**LINCOLN PARK PLANNING COMMISSION**  
CITY HALL – COUNCIL CHAMBERS  
1355 SOUTHFIELD ROAD  
LINCOLN PARK, MICHIGAN

City of Lincoln Park,  
Wayne County, Michigan  
**SITE PLAN DOCUMENTS**  
Prepared For  
White Castle Systems

Project Name  
**White Castle - DE #15**  
**2115 Fort Street**

White Castle, 2115 Fort Street  
**Site Plan Review**

**FRONT ELEVATION**  
SCALE: 1/4" = 1'-0"

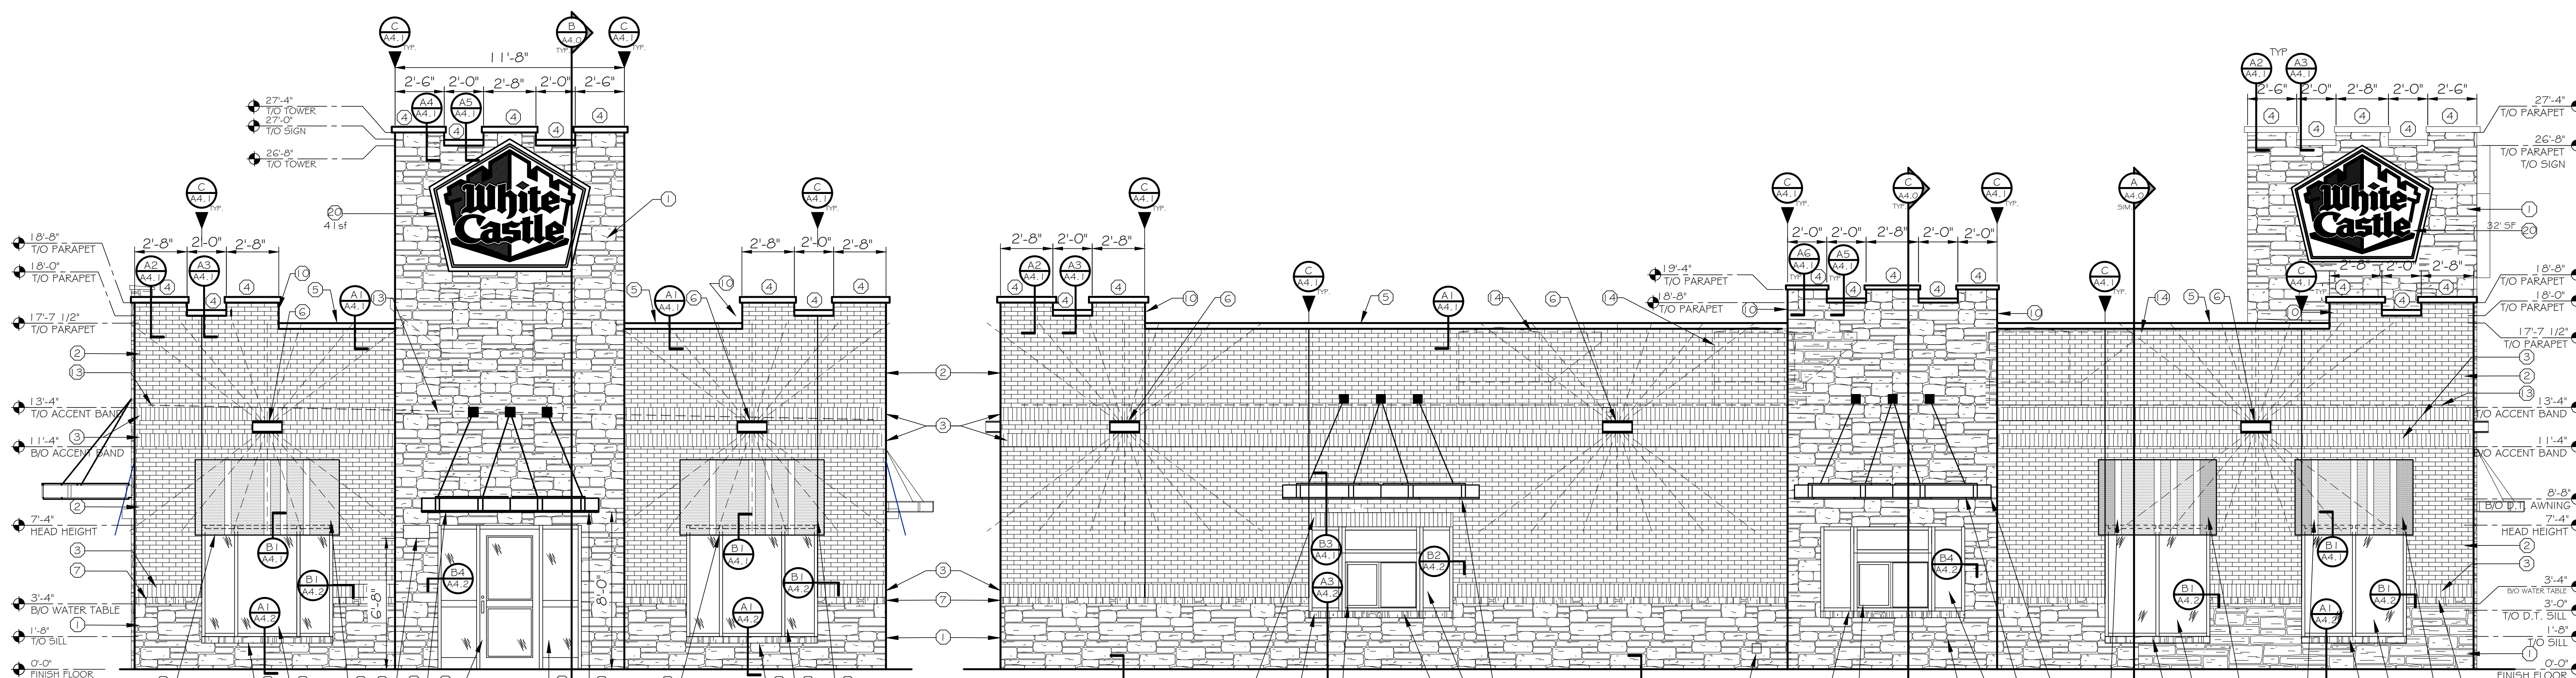
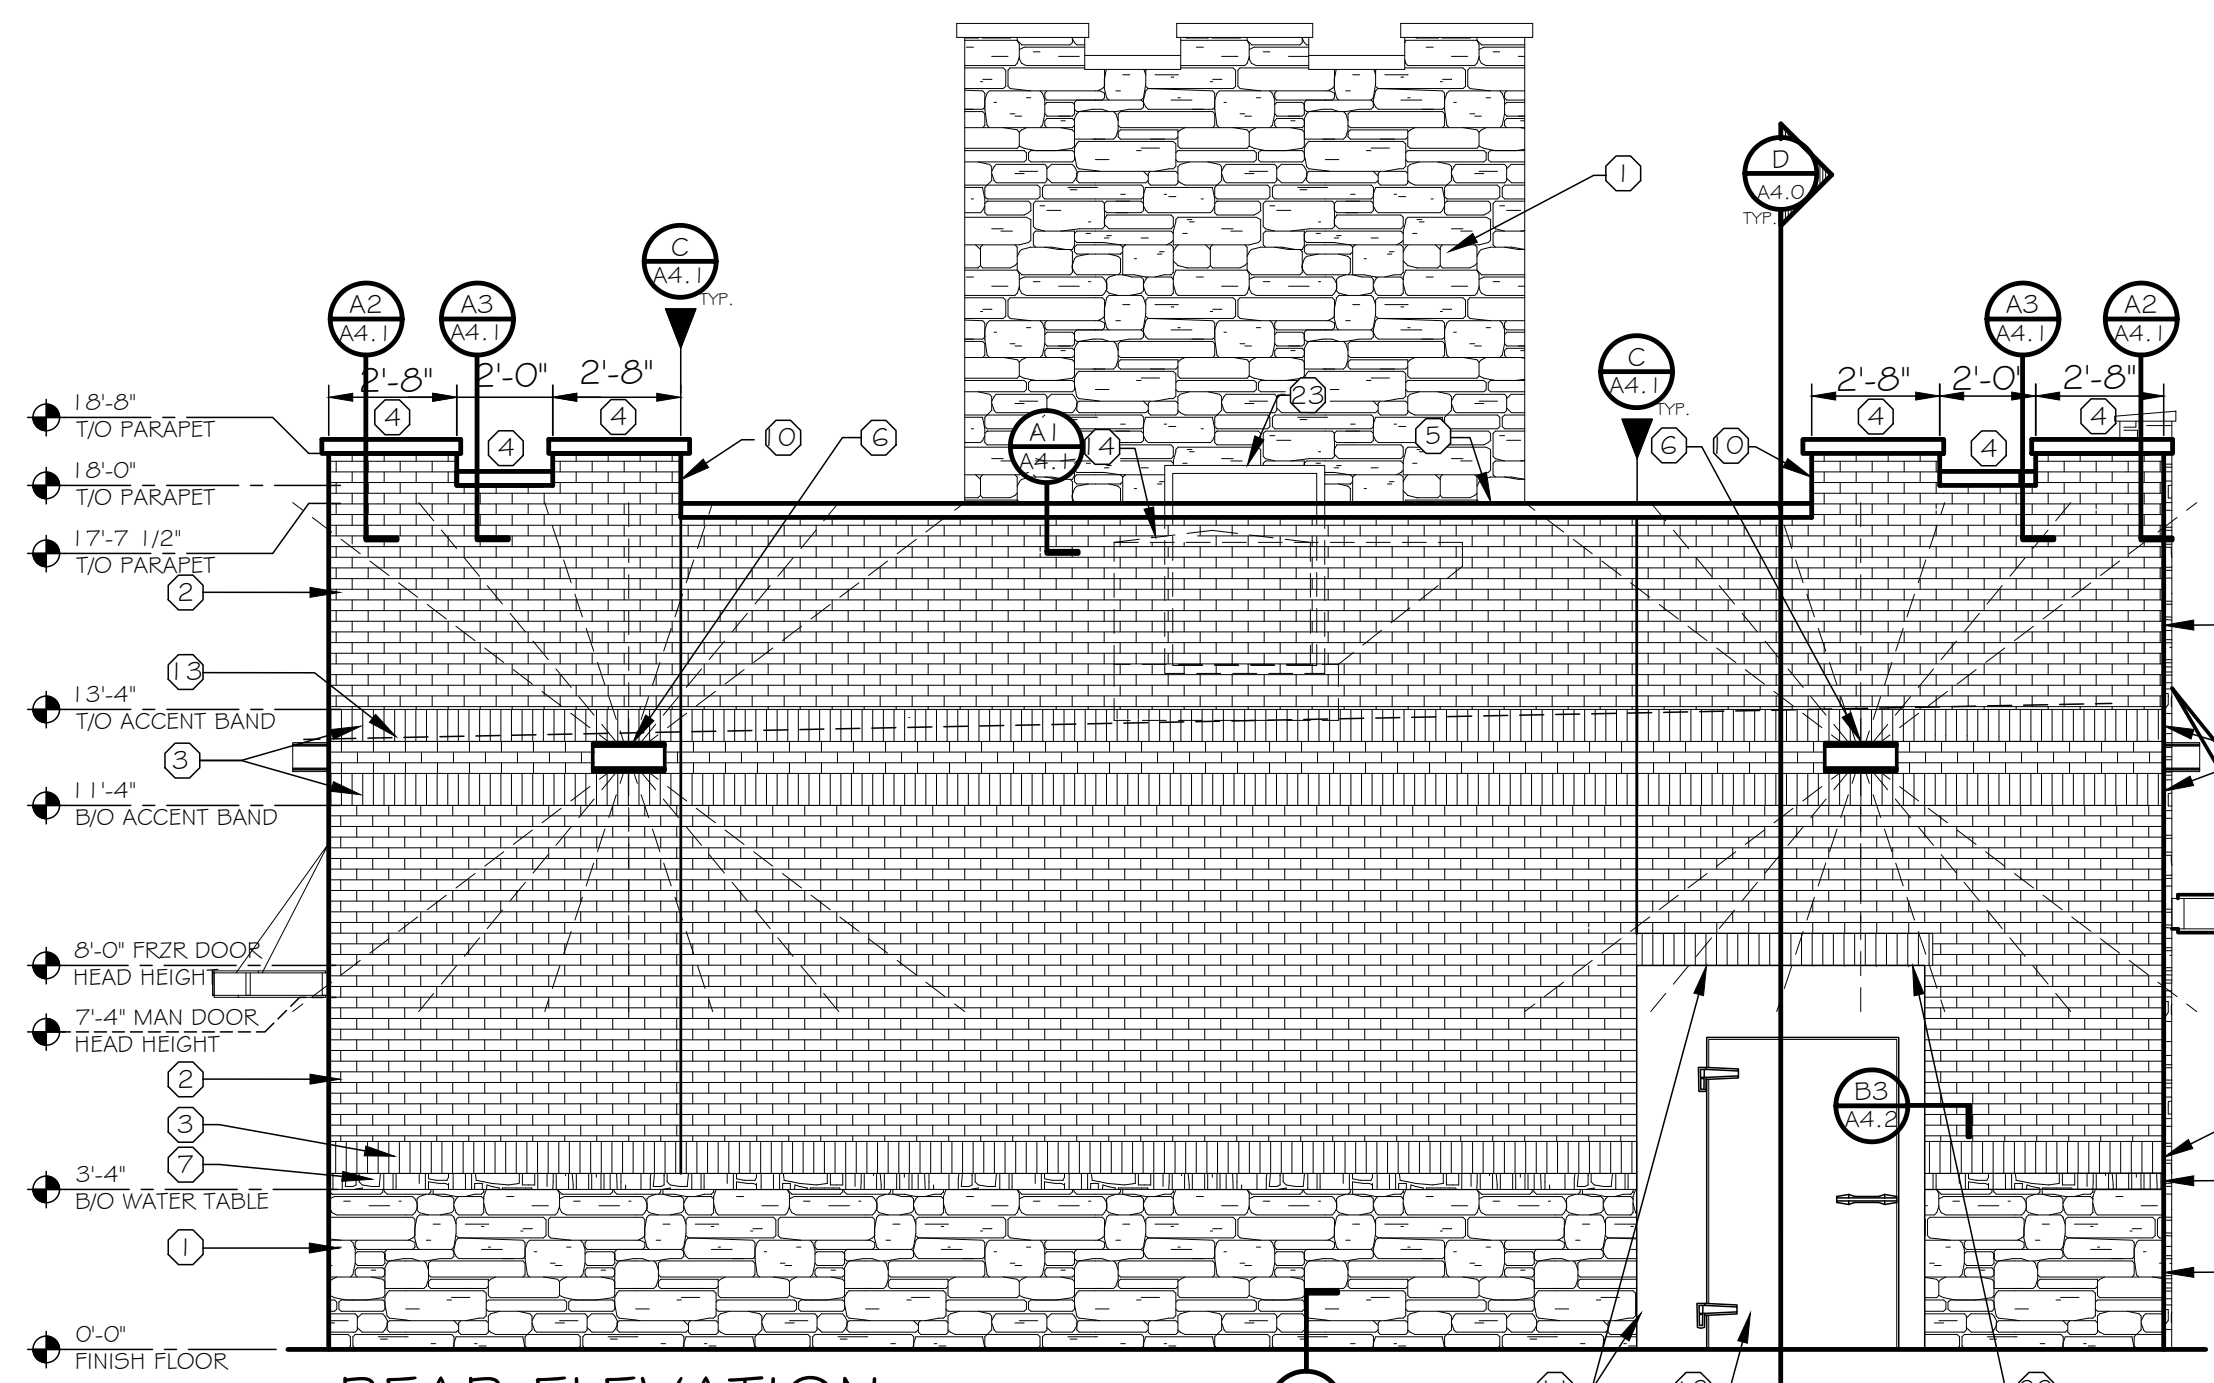
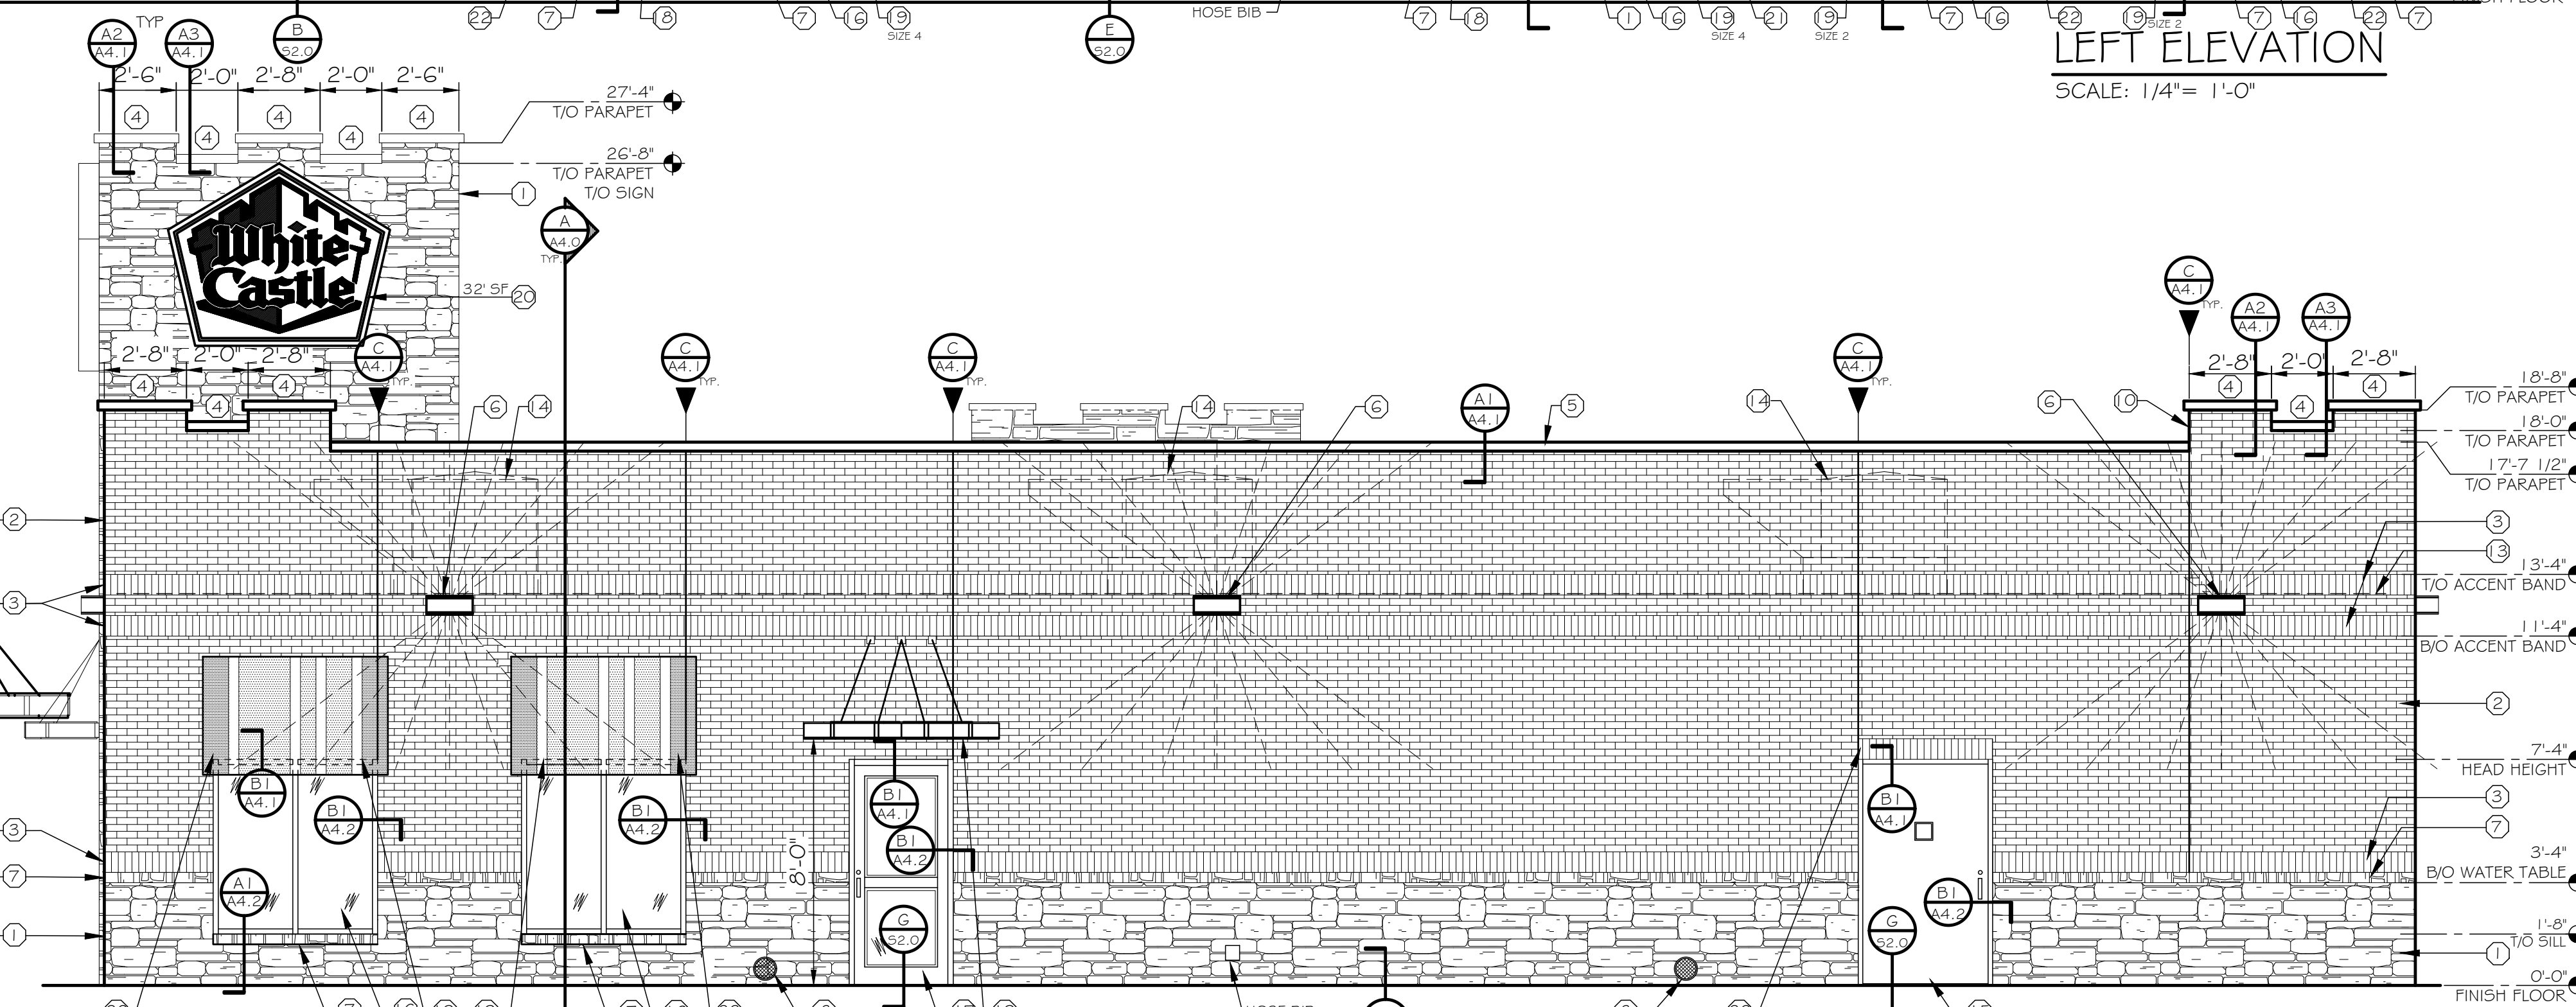
- Public entrance to face Fort Street.
- Applicant to address shortfall in window requirements; glazing requirements to be addressed simultaneously
- Building materials shall be reviewed by the planning commission.
- Foundation plantings to be added where practical

- Public entrance to face Fort Street.
- Applicant to address shortfall in window requirements; glazing requirements to be addressed simultaneously
- Building materials shall be reviewed by the planning commission.
